TO: ALL ROOTES DEALERS

MODEL: SUNBEAM IMP

SUBJECT: CARBURETOR - CABLE OPERATED THROTTLE CONTROLS  
(1) STICKING THROTTLE (2) INABILITY TO OBTAIN FULL THROTTLE

Fig. 1.

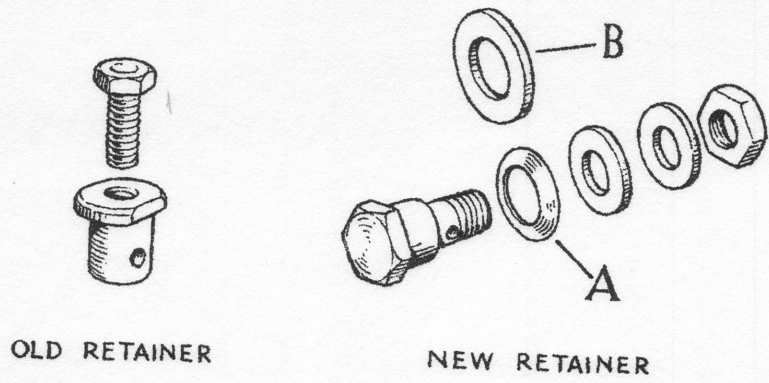
NOTE - Waved washer (A) 9055017 not required at engine end.)  
Plain washer (B) 9067236 not required at pedal end. ) See Fig. 1

Fig. 2.

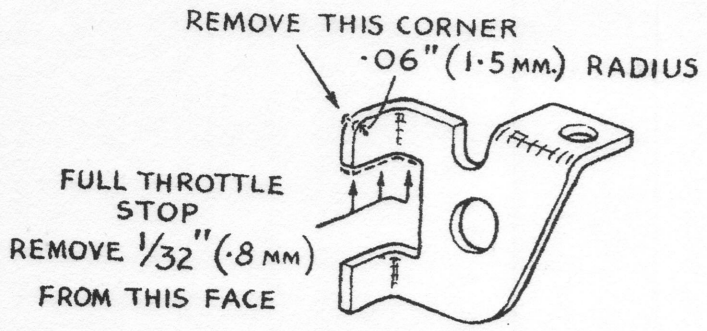
(2) INABILITY TO OBTAIN FULL THROTTLE - This may be caused by the stop bracket on the accelerator pedal and bracket assembly preventing full movement of the cable operating arm. Remove the assembly from the vehicle and modify the stop bracket by removing 1/32" (.8 mm) from the contact surface of the full throttle stop only (See Fig. 2).

Radius the top corner of the stop bracket as shown in Figure 2 to avoid the possibility of a foul against the toe board swaging.

Fig. 3.

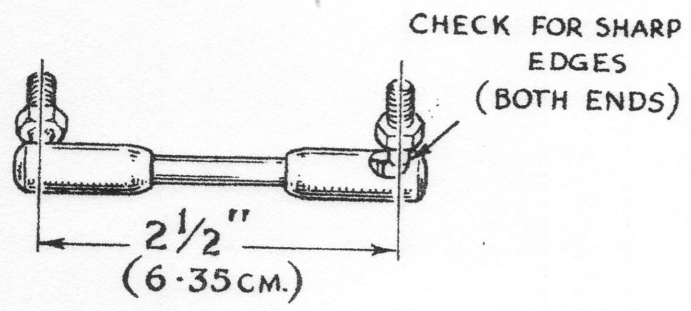
In addition, check the length of the extendable connecting rod 7102564 between the centers of the ball ends. Replace if shorter than the specified 2.50" (6.35 cms.) See Figure 3. Check also that excessive 'necking' of the ball joint shank has not taken place. Remove any sharp edges or burrs from the edges of the ball joint orifices.
